ULNRC-04353

**DOCKET NUMBER 50-483
CALLAWAY PLANT
UNION ELECTRIC COMPANY
OPERATING LICENSE AMEMDMT REQUEST:
"UNREVIEWED SAFETY QUESTION REGARDING
INSTALLATION OF LOAD TAP CHANGING TRANSFORMERS TO
PROVIDE OFFSITE POWER TO THE SAFETY RELATED ELECTRICAL
BUSES"**

Pursuant to 10 CFR 50.90, AmerenUE hereby requests an amendment to the Facility Operating License No. NPF-30 for Callaway Plant. Upon approval of this request the proposed changes will be incorporated into the Callaway Plant (Updated) Final Safety Analysis Report.

Figure 1
LTC and Capacitor Bank Voltage Control

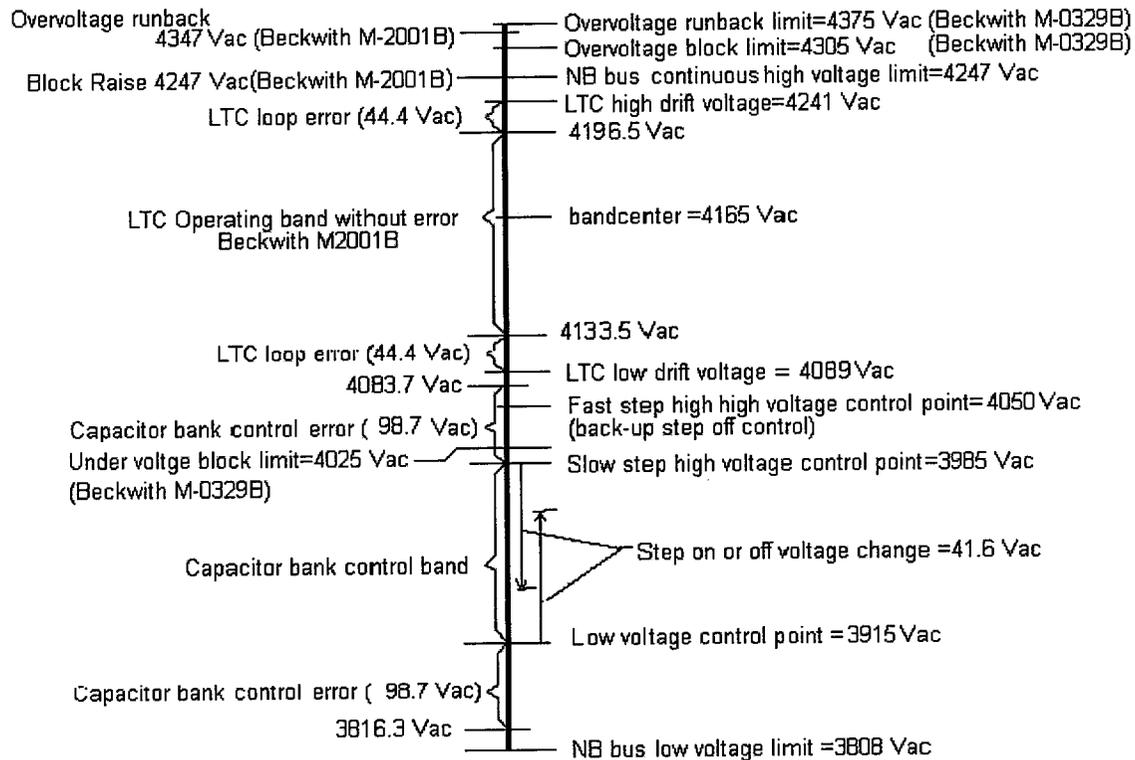
The new transformer with automatic load tap changer, in conjunction with the installed 6 MVAR capacitor bank, provides voltage support for the associated Class 1E NB bus. This is accomplished by making tap changes, as required, to maintain an acceptable NB bus voltage. The voltage control range for the new transformer will be coordinated with the existing capacitor bank controls as shown in the figure 1 below to assure that the capacitor bank steps are off when the transformer is operating in its nominal control band.

The control of the tap changer will be automatic, based on the secondary voltage of the transformer. The control circuits will be designed to limit the probability of either an under voltage or over voltage failure by using a Beckwith M-2001B primary controller and Beckwith M-0329B backup controller. The Beckwith 2001B is set to control the secondary voltage at $4165 \pm 31.5V$. The Beckwith M-0329B backup relay will block tap changer signals to raise voltage if the secondary voltage is above 4305V and create a tap changer signal to lower voltage if the secondary voltage is above 4375V. The Beckwith M-0329B backup relay will block tap changer signals to lower voltage if the secondary voltage is below 4025V. The first tap change will take a minimum of 2.5 seconds with subsequent steps taking about 2 seconds. Each step will vary the NB bus voltage by approximately 1%. The control settings in Figure 1 are established by load-flow analysis.

With both systems in operation, the general response to a LOCA is for the capacitor bank to provide a rapid voltage increase if needed and then the LTC will step to correct the voltage back to a 4.16 kV level and thus turn the capacitor bank off. The voltage control systems function to ensure that the voltage at NB01 and NB02 is sufficient to reset the safety related degraded voltage relays and loss of voltage relays before time limits are exceeded. With this, the preferred off site power sources are retained to power the safety related electrical distribution system. The voltage control systems also function to ensure that overvoltages are not present in the safety related electrical distribution system when fed from the preferred power sources.

DATE	N/A	REVISION	1
BY	N/A	DESCRIPTION	LOWER MEDIUM VOLTAGE SYSTEM CLASS 1E 4.16KV SINGLE LINE METER AND RELAY DIAGRAM
CHKD	N/A	DATE	CALLAWAY PLANT
APP	N/A	LOCATION	ST. LOUIS, MO
UNION ELECTRIC COMPANY		E-21N02(0)

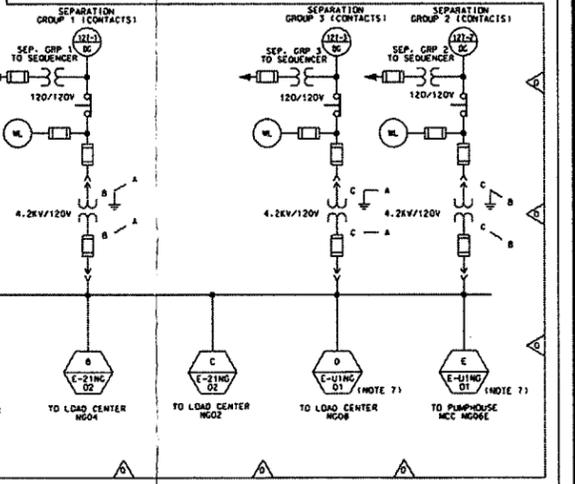
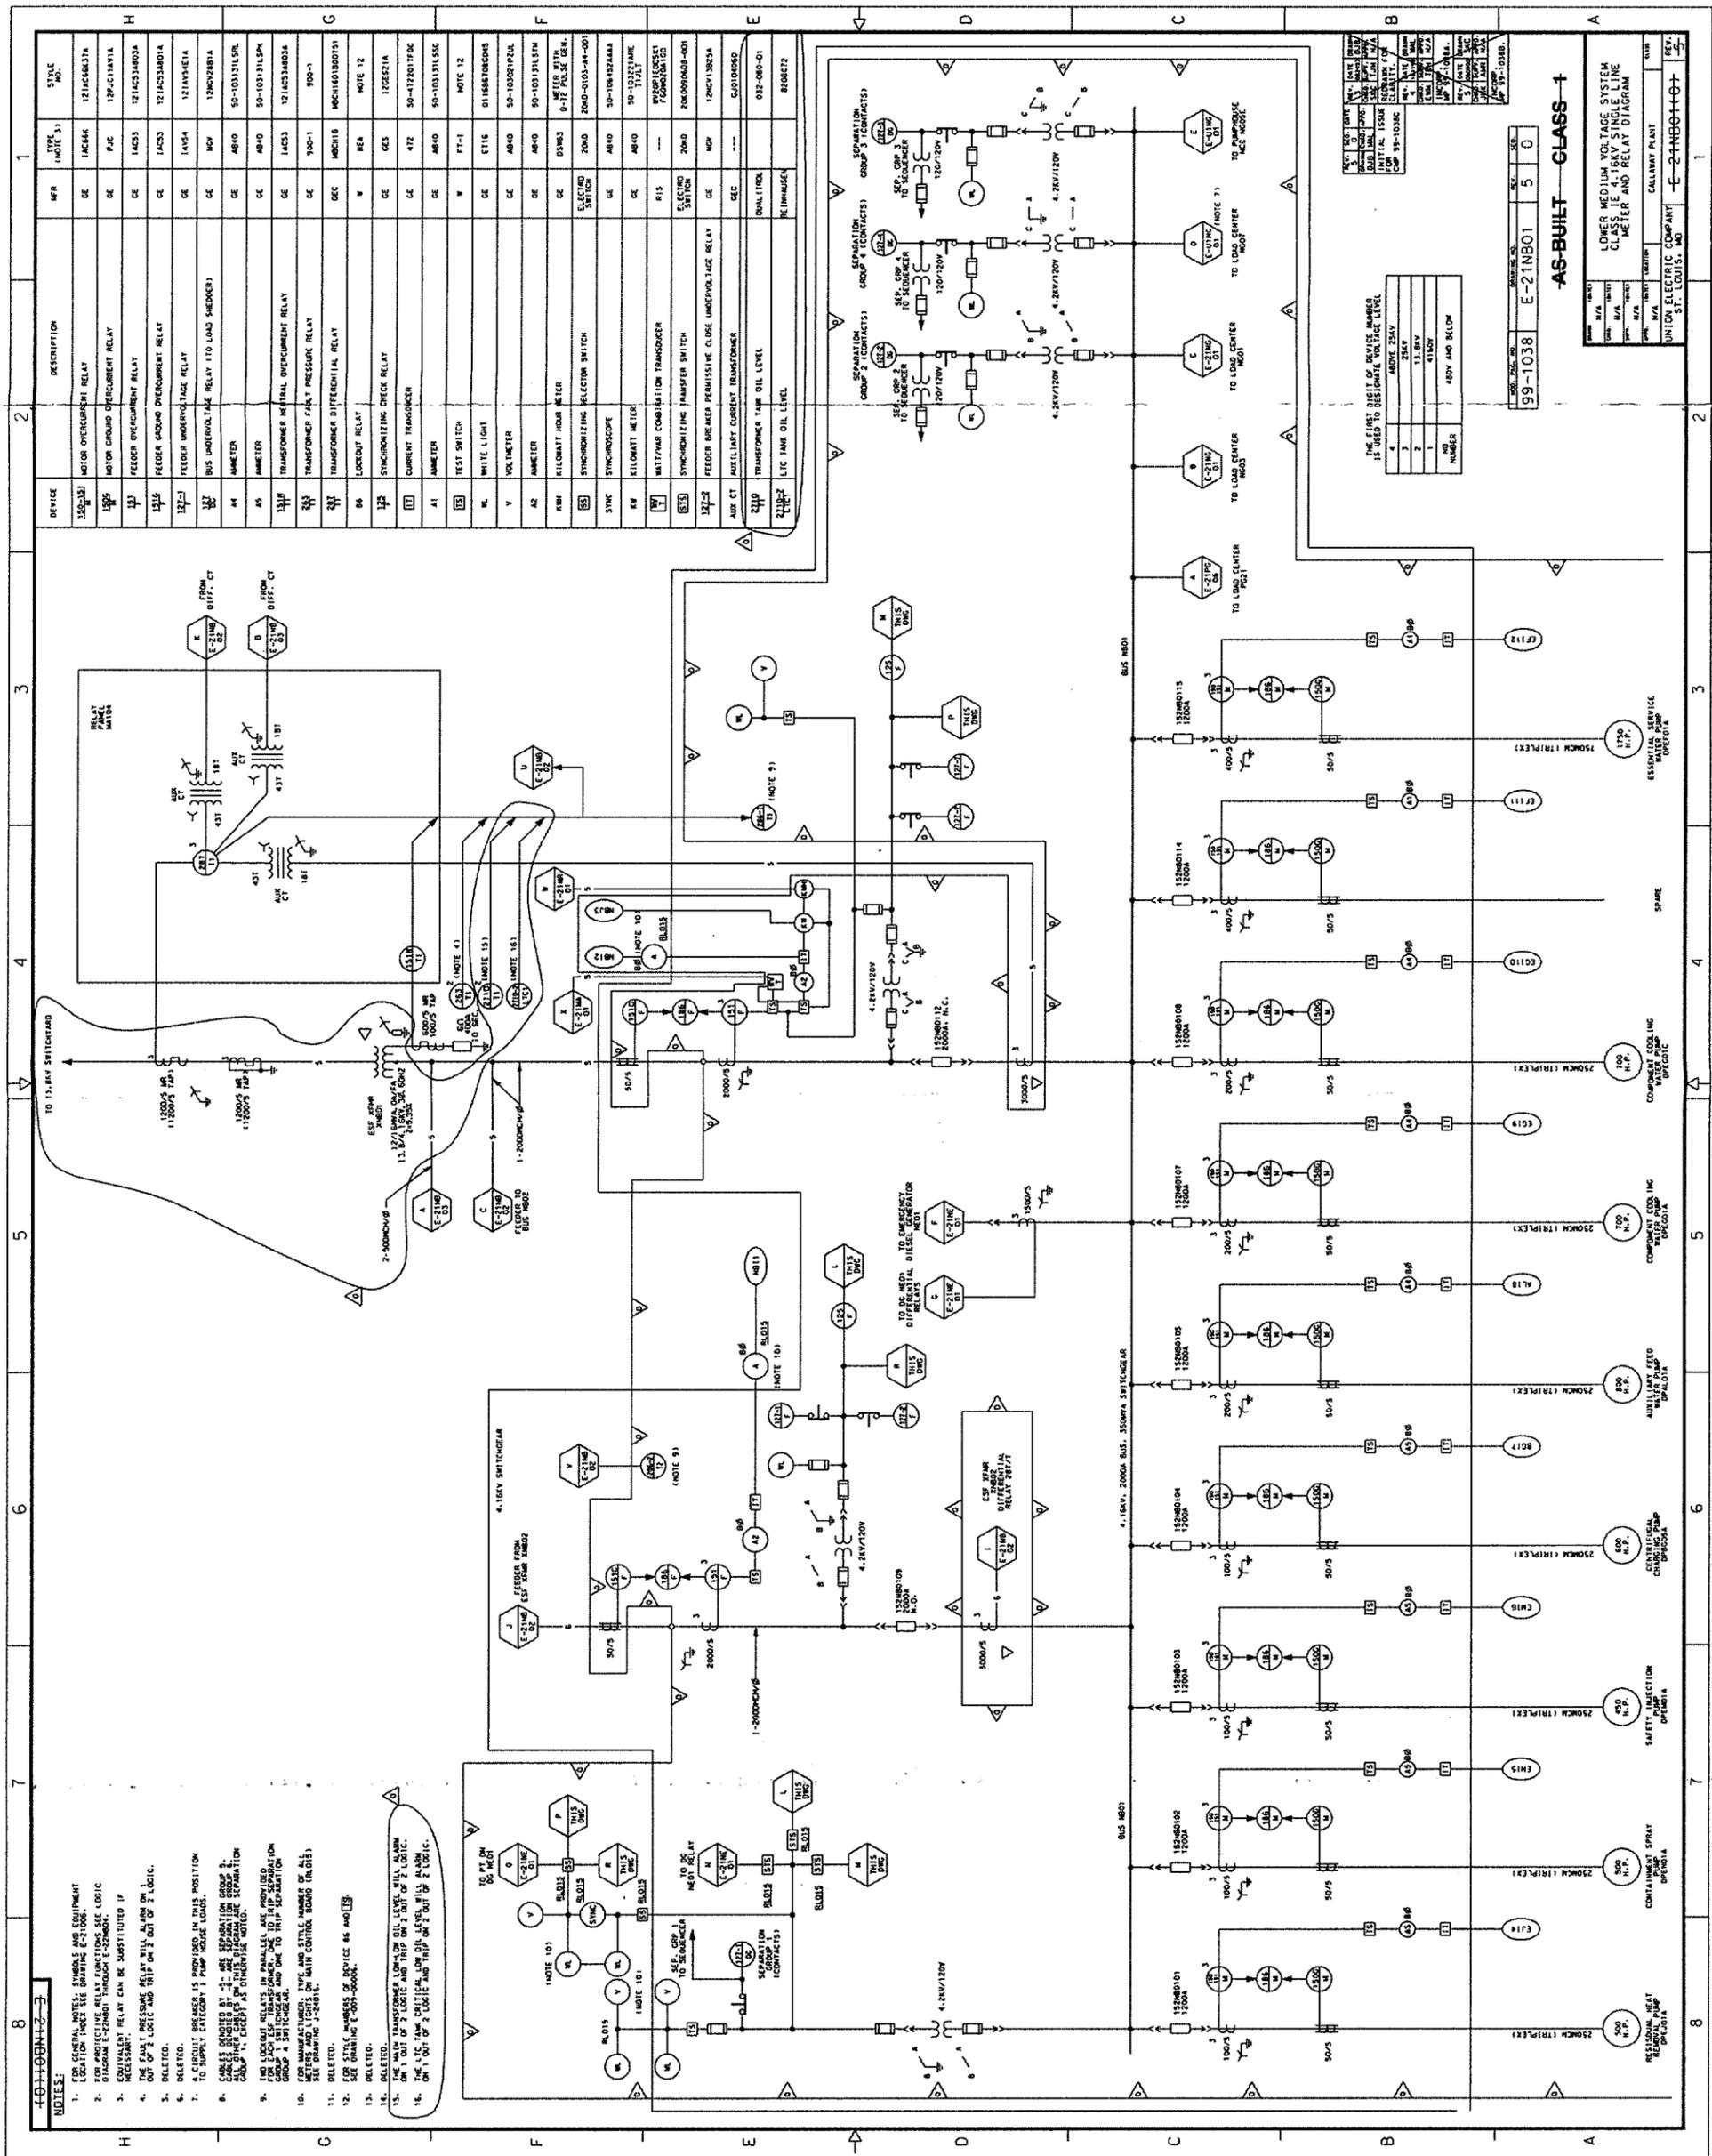
Drawings E-¹1NB01 and E-²1NB02, Single Line Meter and Relay Diagrams for the Safety-Related 4.16-kV Busses NB01 and NB02 show the surveillance details of the ESF transformers and their associated 4.16-kV busses. Table 8.3-4 of the FSAR, Failure Modes and Effects Analysis, shows the system failure modes and the method of such failure detection.

FSAR CN 00-045
Modification
Drawing incorporated
by reference into
FSAR Section B.2
w/m 12/20/00

FSAR CN 00-0045
 Modification
 Drawing incorporated
 by reference into
 FSAR Section B.2
 Wm 12/20/00

CALLAWAY PLANT
 FIGURE 8.3-3
 LOGIC DIAGRAM STANDBY GENERATOR
 EXCITATION CONTROL
 (E-224NE01-2)
 REV. 01-75
 0794/11/01

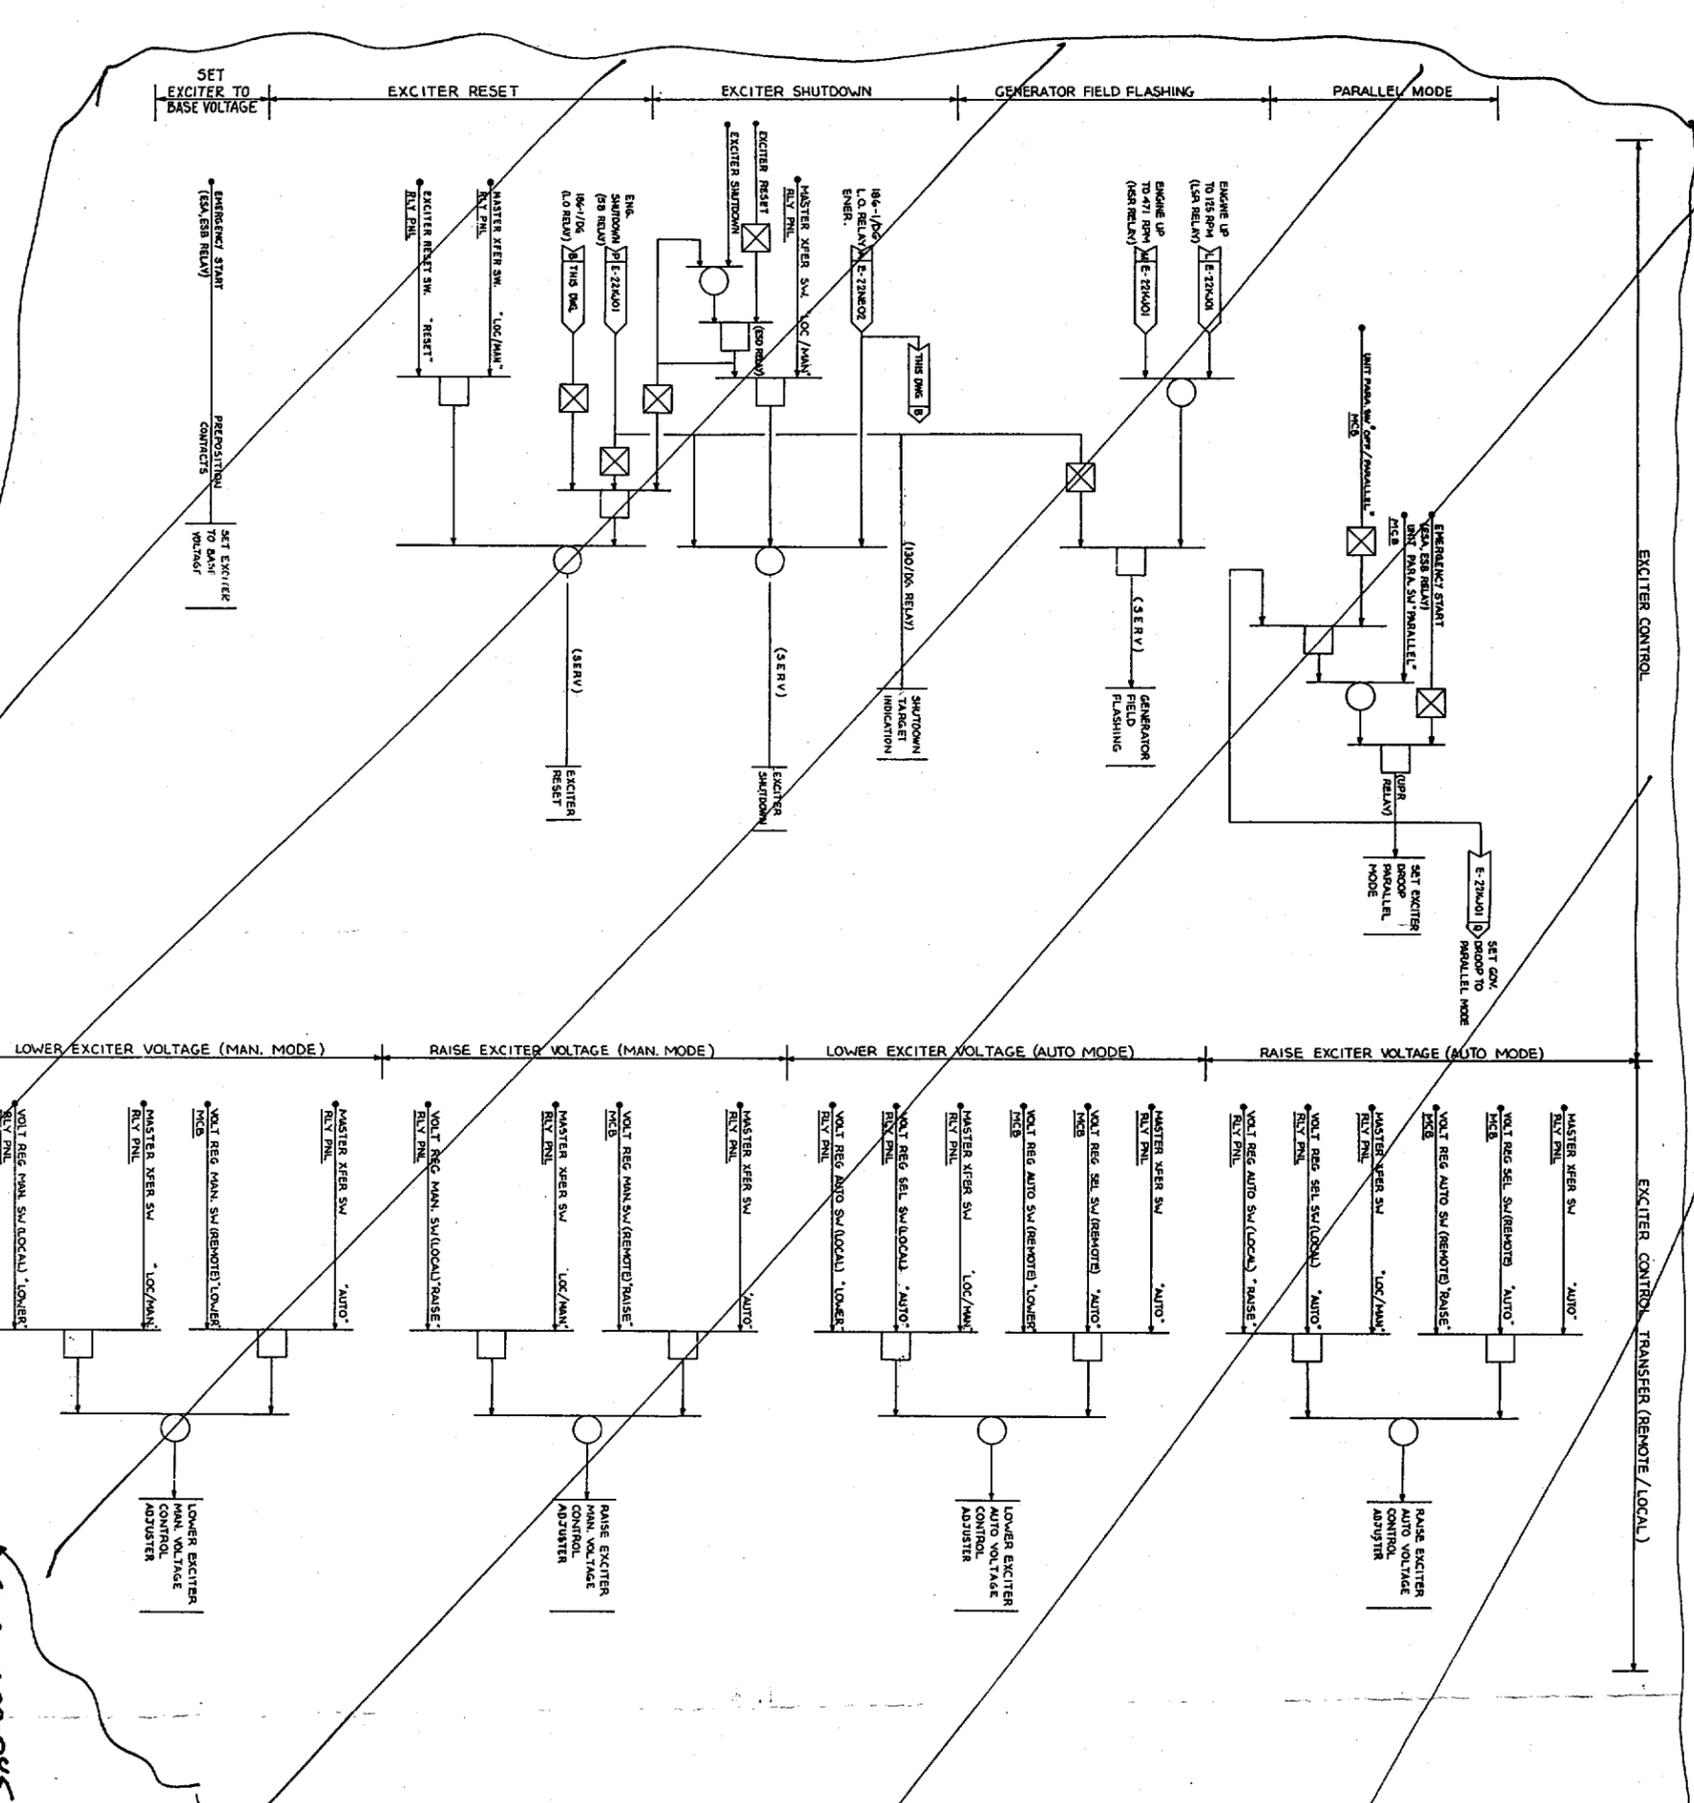
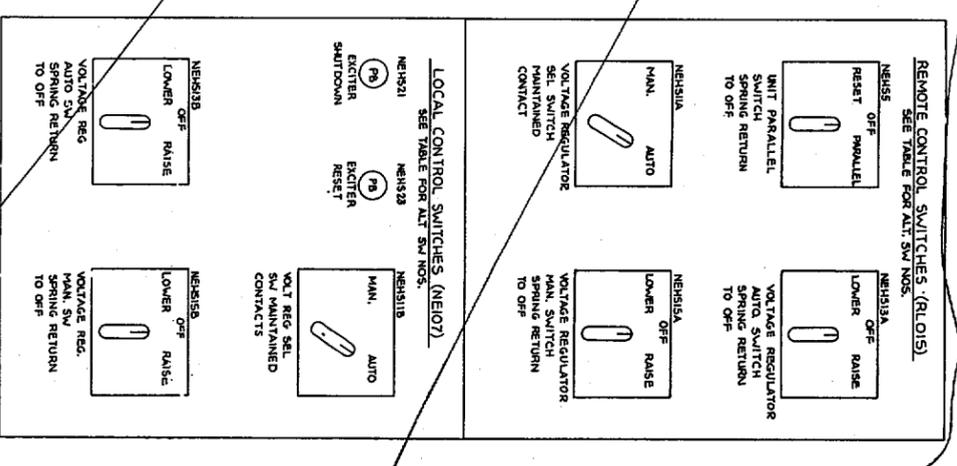
FSAR Figure 1.2-1 shows the location of the ESF transformers, FSAR Figure 8.3-1 Sheet 1 is a one-line diagram of the electrical distribution system, and FSAR Figure 8.3-3 shows the voltage control system interface with the Emergency Diesel Generator. These Figures are part of the proposed update per 10CFR50.71(e) and are included in Attachment 3. These updated Figures and the text portions of Attachment 3 reflect this license amendment request in the FSAR. The FSAR will be updated in accordance with 10 CFR 50.71(e) based on amendment approval.

FSAE CW 00-045
 W/M 1/10/00
 SEE MOD DRAWINGS
 99-1038 E-224NE01-2
